May 2023
FL951A
NHTSA #22V-654
Transport Canada #2022-483

Subject: Western Star Grill Bezel Covers

Models Affected: Specific model years 2020-2023 Western Star 47X and 49X vehicles manufactured March 20, 2019, through August 25, 2022.

Fig. 1, Masking Tape Locations

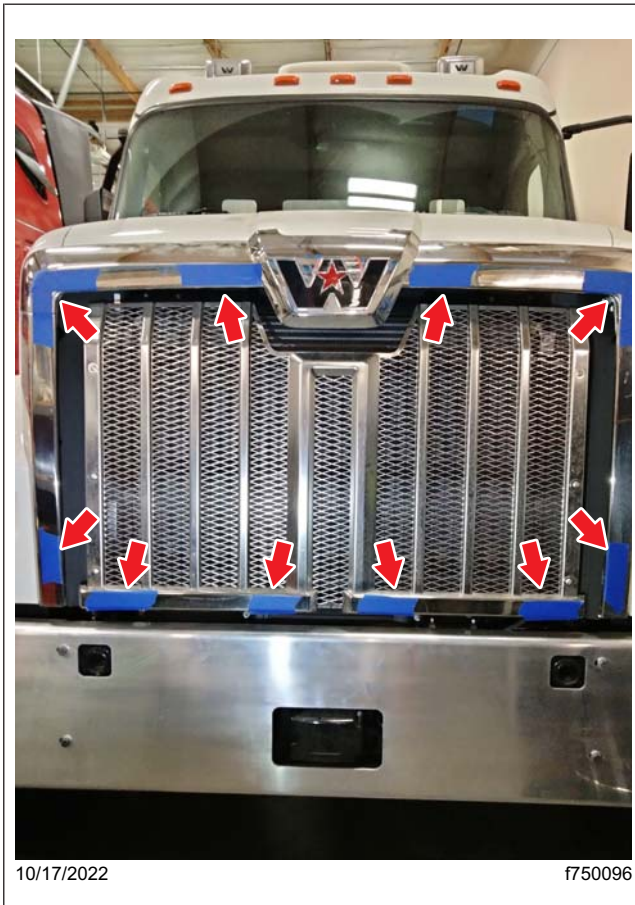
5. Cover the bezel areas that need to be drilled, using masking tape. See **Fig. 1**.

Fig. 2, Hood Handle Removal

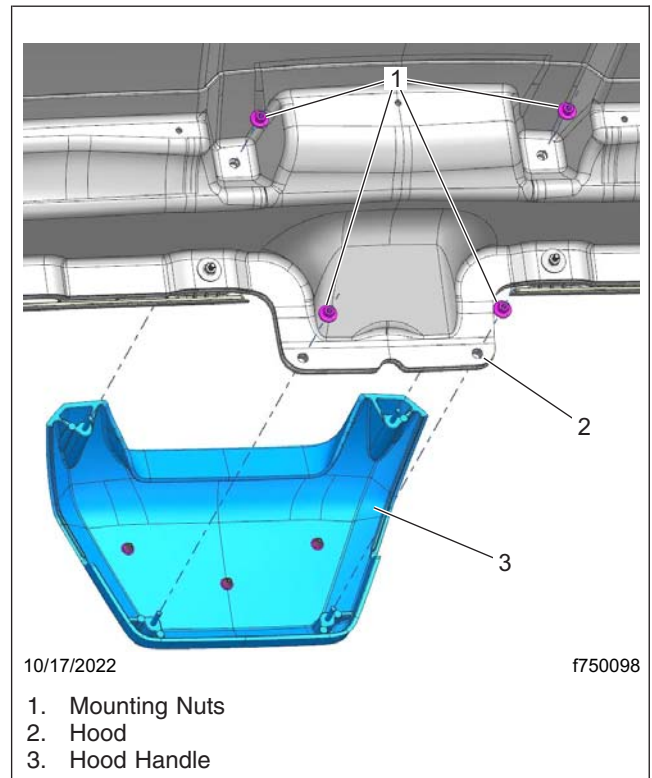
6. Remove the four mounting nuts that attach the hood handle to the hood. See **Fig. 2**.

7. Remove the hood handle.

Fig. 3, Drilling Location Measurements (left-hand hood and grill bezels shown)

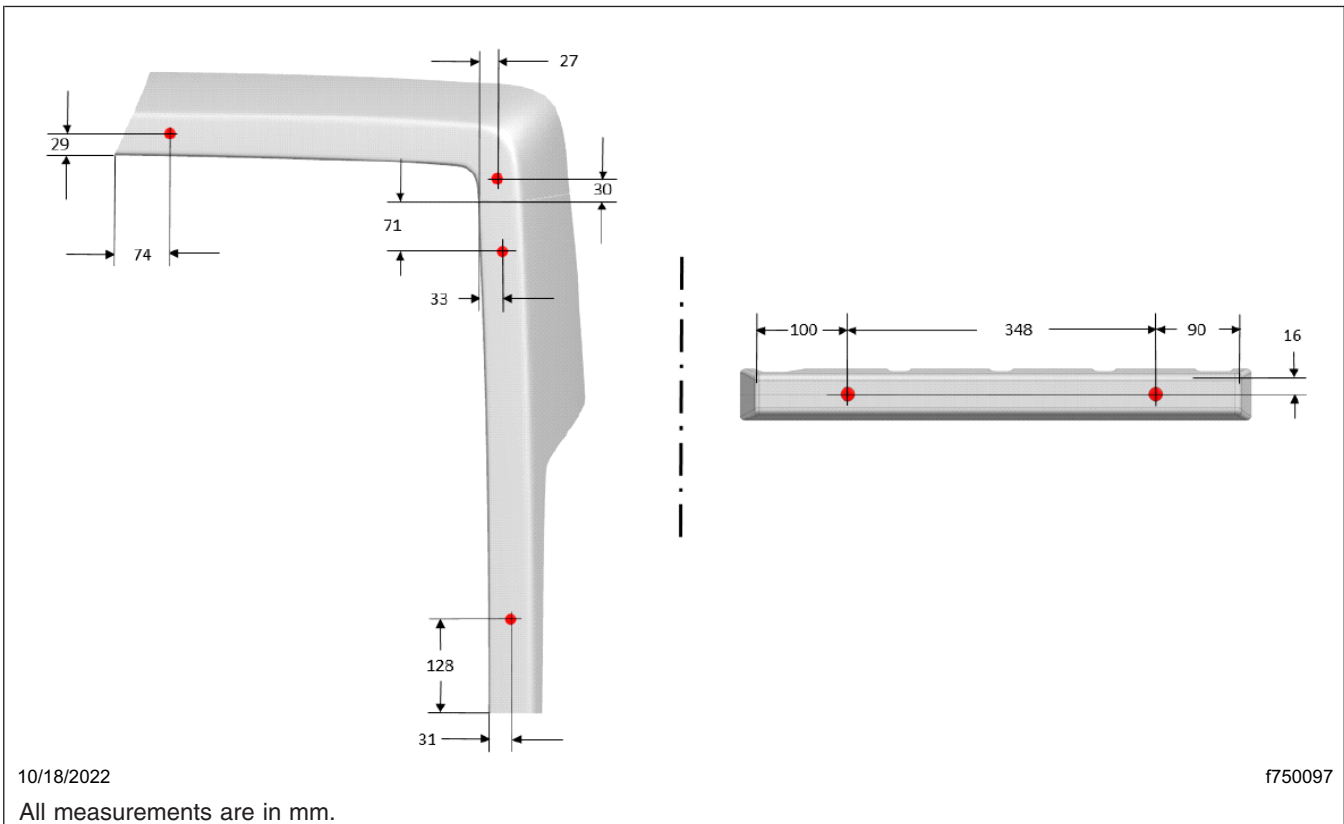
The upper and the side bezels curve together at the upper corners. Use a straight edge to precisely mark the drilling locations.

8. Mark all the drilling locations using the measurements provided in [Fig. 3](#).

9. Center punch the rivet locations, then use a 9/64-inch drill bit to drill 12 holes in the hood bezels.
10. Deburr the holes drilled in the hood bezels.

Fig. 4, Rivet Locations

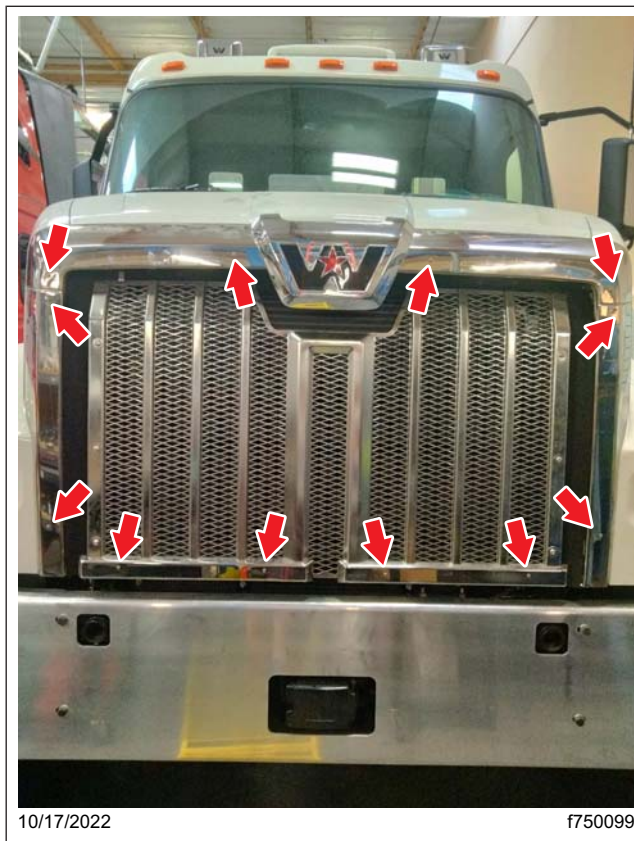
11. Install the rivets into each drilled hole. **Figure 4** shows the rivets installed on the hood bezels.

12. Position the hood handle on the hood by inserting the handle-mounted studs into the respective holes on the hood.
13. Install the four mounting nuts. Tighten the nuts 60 lbf-in (678 N-cm).
14. Clean a spot on the base label (Form WAR259) and attach a campaign completion sticker for FL951 (Form WAR260), indicating this work has been completed.
